From: [Brandt Melick](#)
To: [Wendy Farley-Campbell](#)
Cc: [Jed Truett](#); [Michael Pearson](#); [John Pearson](#); [Nancy Pearson](#)
Subject: 21-051 Fairway Estates (PC 21 39 SUB 03 & PC 21 40 PUD 02) Conditions of Approval
Date: Wednesday, May 10, 2023 3:35:55 PM
Attachments: [21-051 FairwayEstates_Memo_ConditionsApproval_20230510.pdf](#)
[21_051_Fairway_Resolution_Fairway_Estates_2-3-4_Proposed_5-23-23.pdf](#)
[21_051_Fairway_Preliminary_Utility_Plan_051023.pdf](#)
[21_051_Fairway_ParkLand-Pathway_OpenSpace_051023.pdf](#)

**Substantive: Fairway Estates Phase II PUD/Subdivision
Application – Conditions of Approval**

Date: May 10, 2023
To: City of Florence, Planning Department
From: Metro Planning, Inc.
Subject: Substantive Comments for Conditions of Approval

Agency File No.: PC 21 39 SUB 03 & PC 21 40 PUD 02
Agency Contact: Wendy Farley Campbell, Planning Director, AICP

Map 1 - Fairway Parkland-Pathway Open Space²

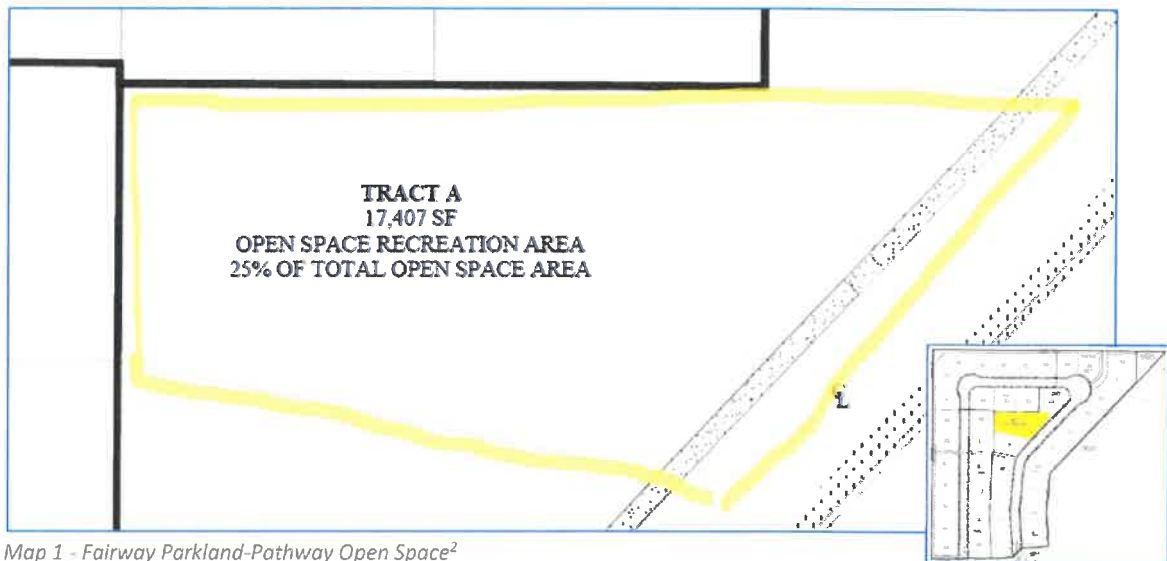
15. ~~Upon submittal of the Final PUD application shall include, the applicant shall demonstrate evidence that active recreational uses throughout~~ the recreational open spaces will be provided in greater amount than the 25% required. A final open space and recreation space plan shall be provided with Final PUD application that includes the sq. ft. calculations, percentages and construction details, replanting plans and recreation amenities.

Response: Applicant provides 25.4% of overall open space as recreational open space with Tract "A" at 17,407 SF. Total required open space is 68,470 SF, i.e., $(25.4\% = (17,407 / 68,470))$. It is important to note that open space nature paths are recreational in nature and should also count toward the requirement. Exact calculation will be provided on final PUD, but in no case will the percentage of recreational area fall below 25%.

S - Fairway Preliminary Utility Plan

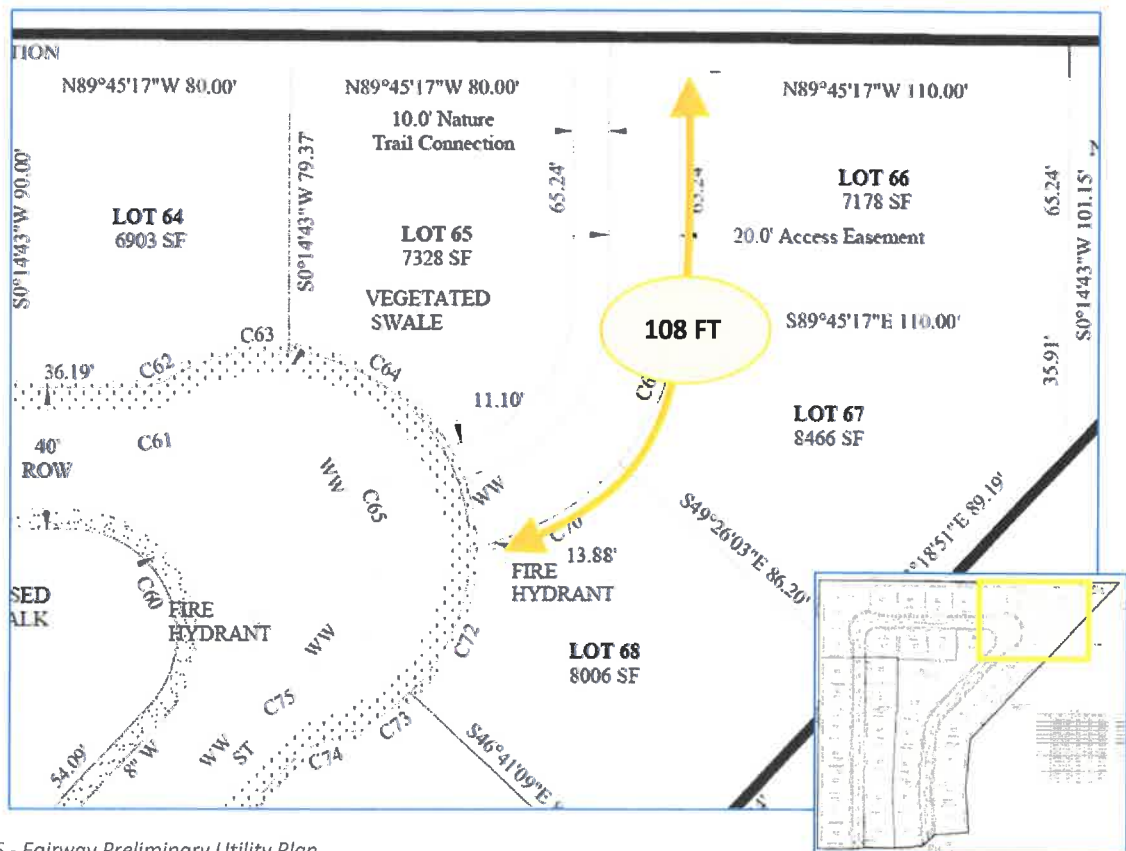
37.36. The driveway serving Lots 65, 66, 67, and 68 shall be paved a minimum width of 18' wide with 20' of unobstructed aisle width and shall be signed "'no stopping" parking prohibited". The driveway shall ~~and~~ include a turnaround meeting figure 10-35(3) if greater than 150' from the entry to the furthest building wall. Any required turnaround may be removed once until through connection onto Rhododendron Drive or east to Oat St. is available and constructed to from the northern city owned property. The pedestrian pathway along this driveway shall be demarcated with either a paint stripe or differing pavement colors or markings. With a minimum width of 10' wide meeting the block length criterion.

Response: Applicant met with Fire Chief Michael Schick, early afternoon May 9, 2023, reviewed the new driveway plan (below), driveway dimensions, proximity to fire hydrant, and proximity to lots 65,67,66, and 68. Fire Chief said that design was sufficient to properly service these properties with current design (without adding a turnaround). As can be seen on the utility plans below, the distance from the street to back of lot 66 is less than the 150 FT requirement.
